Report to the Future Melbourne (Planning) Committee

Agenda item 6.4

**Ministerial referral: TPM-2016-26
552-578 Lorimer Street, Port Melbourne**

PLANNING REPORT**MINISTERIAL REFERRAL**

KEY PLAN

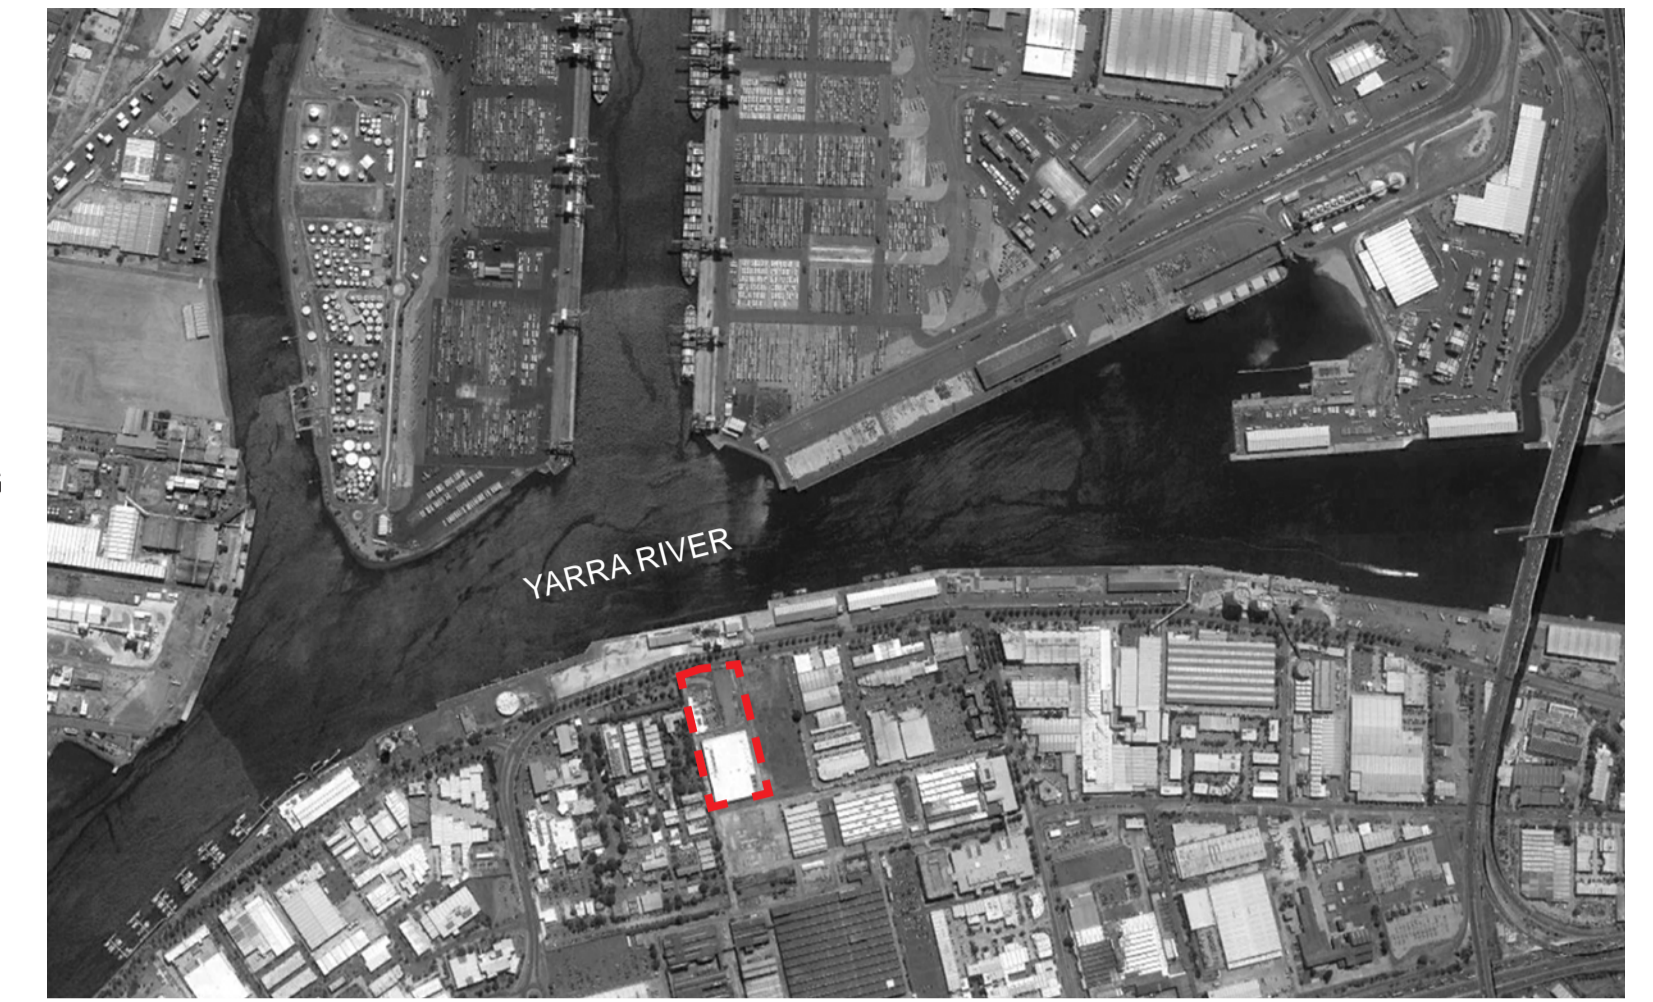
The submitted landscaping plan shows that low level planting is proposed to the front of building along the Lorimer Street boundary. As the ground floor of the building currently presents as a blank concrete façade, it is recommended that a condition be imposed requiring a revised landscape plan which shows deep soil planting of mature trees. This will assist in softening the appearance of the large concrete building as well as enhancing the public realm. This will also partly address Council's Urban Design concerns.

- The areas available for planting at the sides of the building are notably lacking. In conjunction with a holistic WSUD strategy to manage runoff from the considerable expanse of hardstand, we strongly encourage the integration of boundary landscaping along the east and west boundaries to provide shade, reduction in the urban heat island and biodiversity.

6. The site must be landscaped in accordance with the endorsed plans within three months of the completion of the development to the satisfaction of the Responsible Authority. All landscaped areas must be subsequently maintained to the satisfaction of the Responsible Authority.

NORTH & SOUTH ELEVATIONS

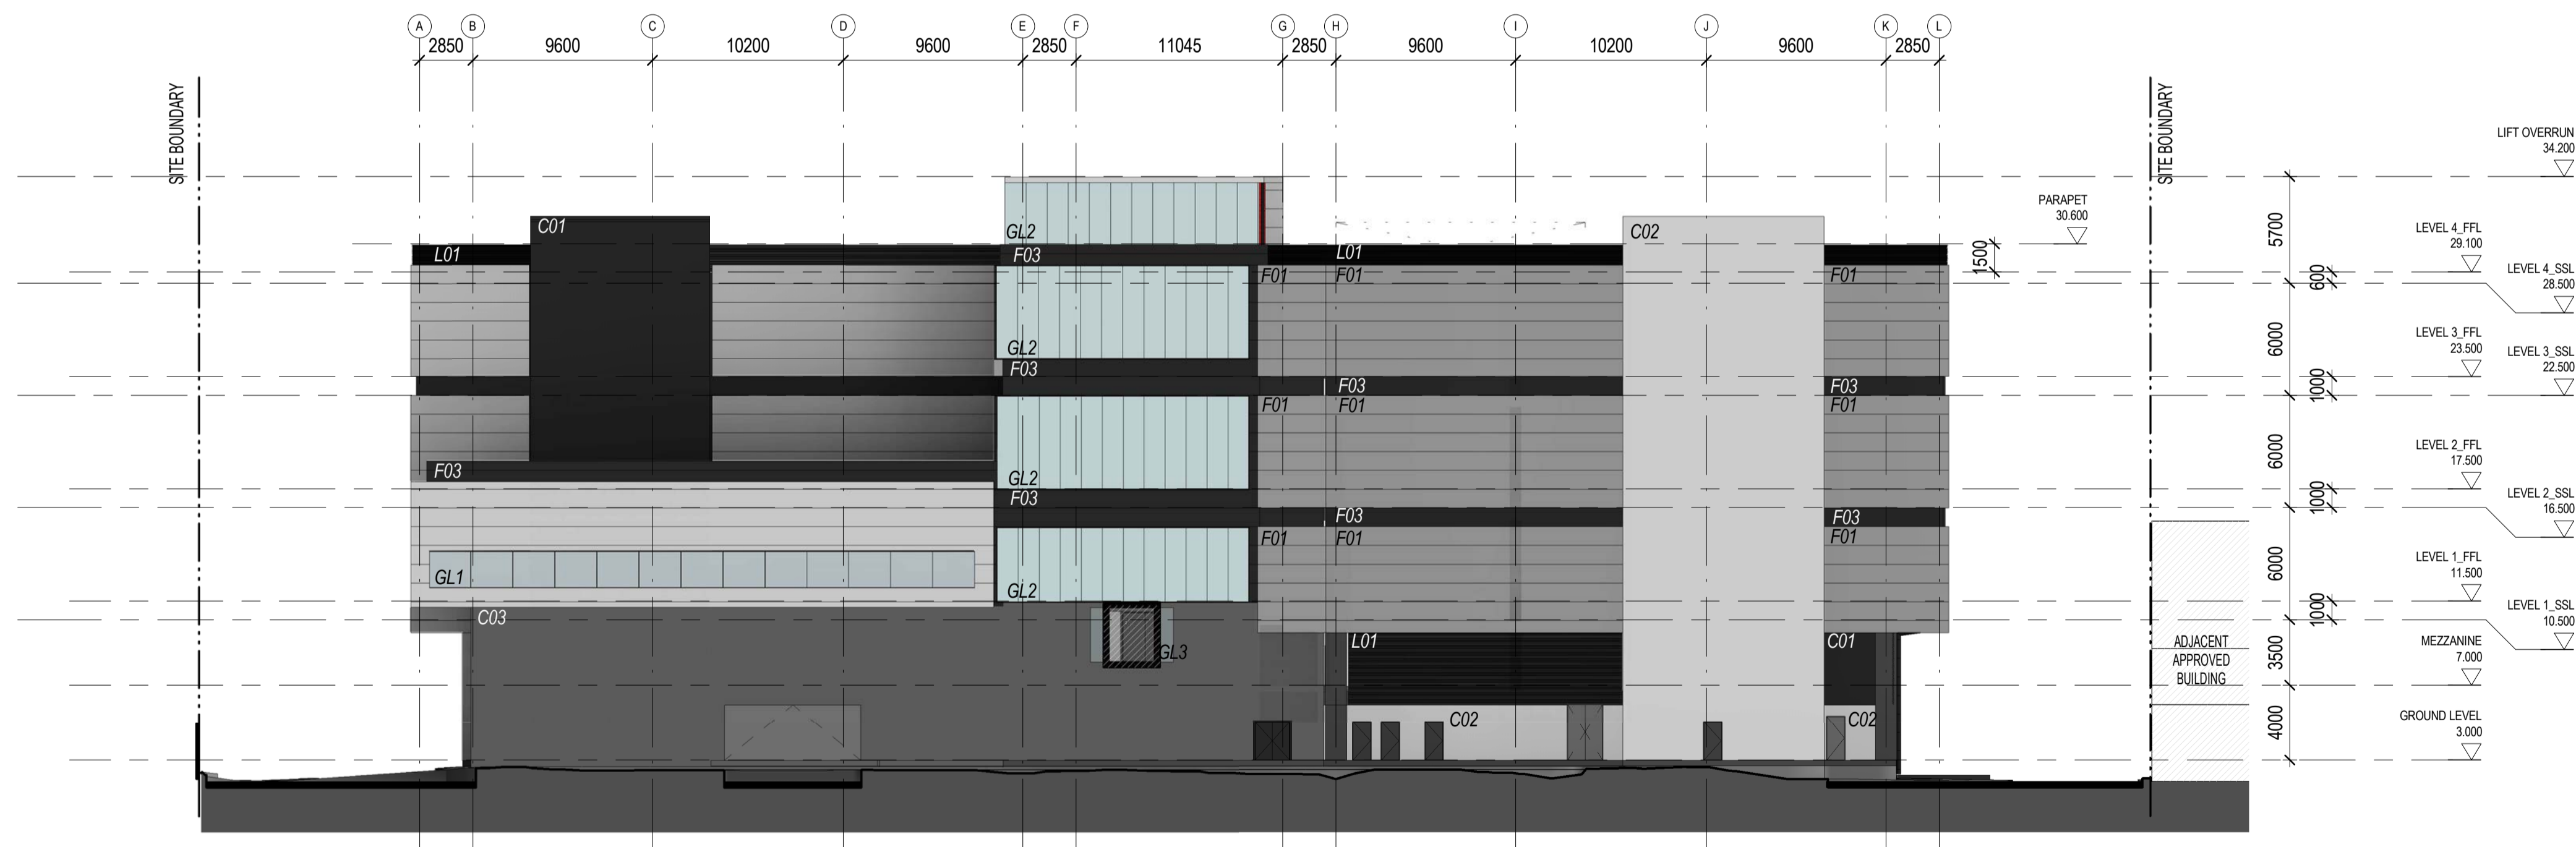
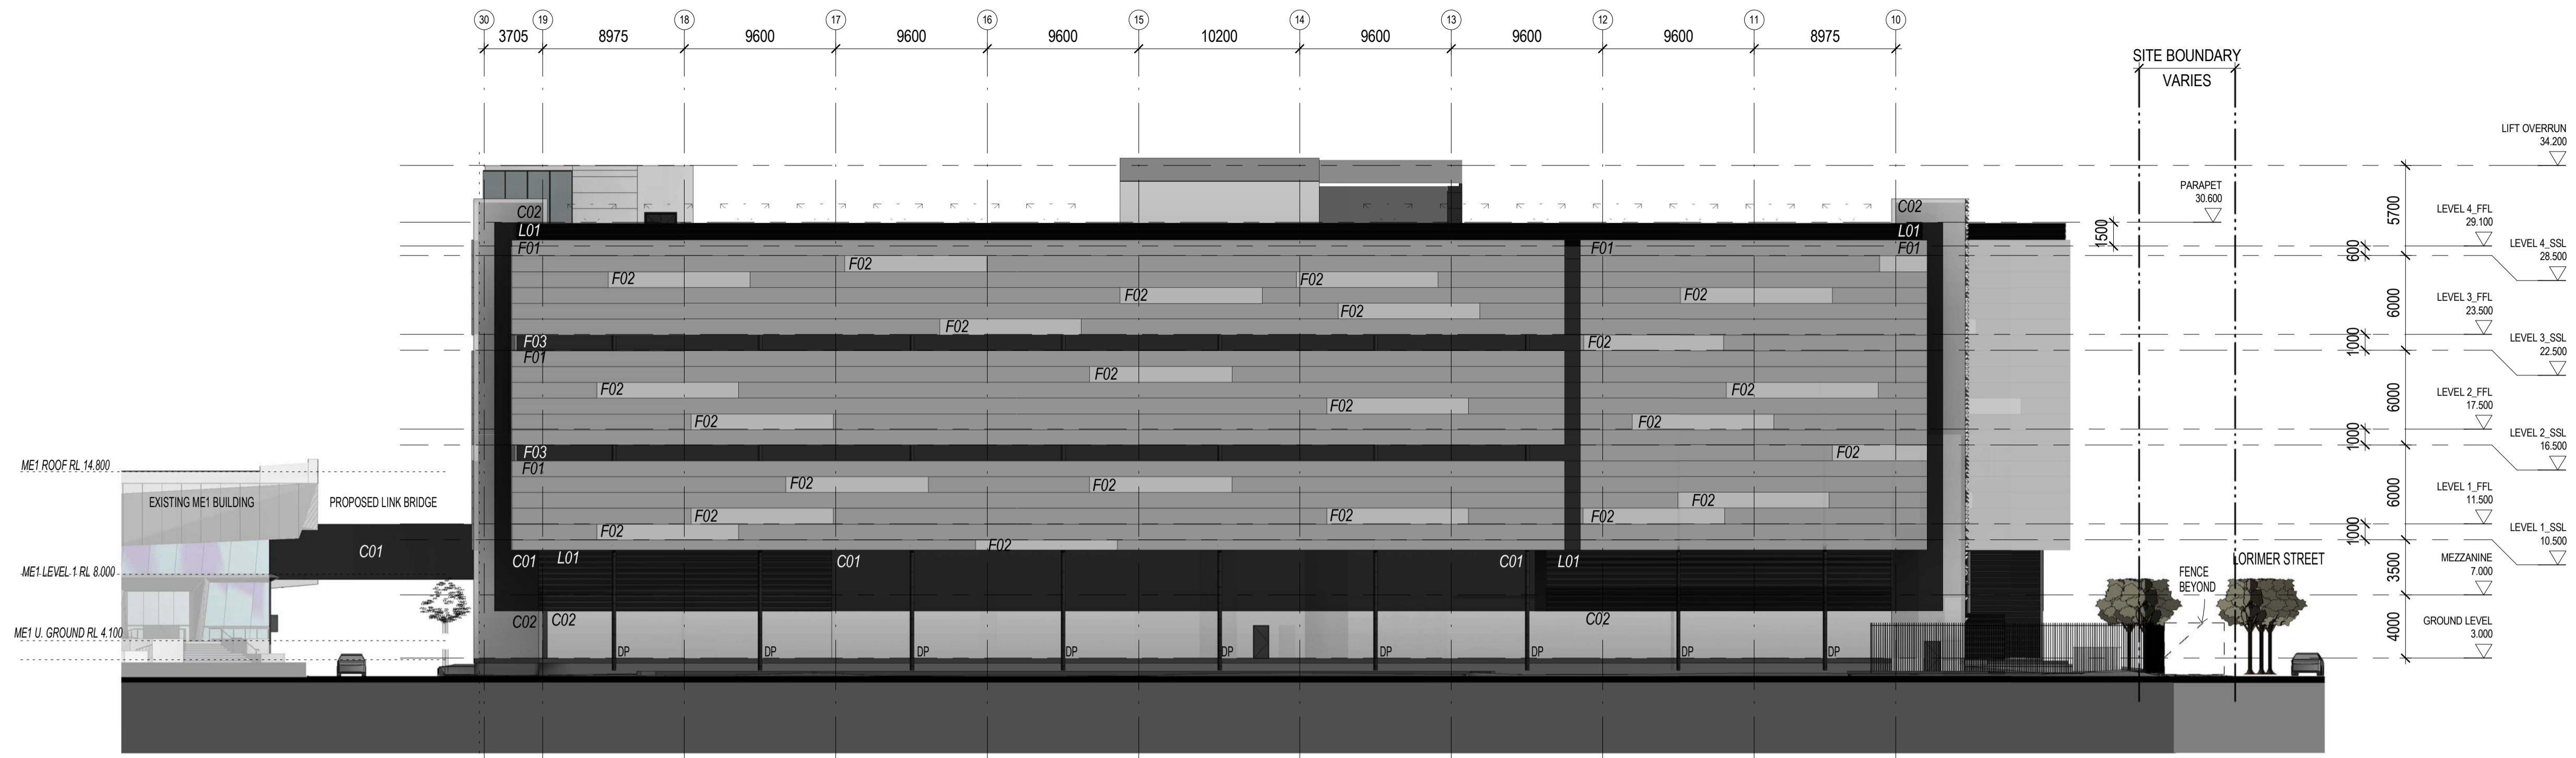
8. Council's Urban Design Department have raised concerns with the blank side elevations and the lack of activation to the street frontage. To address urban design concerns, it has been recommended that the side elevations be further articulated and that an updated landscape plan be submitted showing deep soil planting of mature trees which would assist in softening the presence of the building to Lorimer Street.

The City of Melbourne's urban design team has raised concerns with the flatness of the side elevations of the proposed building. Given that the side elevations will be exposed to oblique views from within Lorimer Street it recommended that should a permit issue, a condition be imposed requiring further articulation of these side facades. This could be achieved by using different architectural treatments to break up the bulk of the facades.

The front façade of the building Lorimer Street contains two architectural elements depicting triangles. This treatment assists in breaking up the bulk of the building as well as providing visual interest.
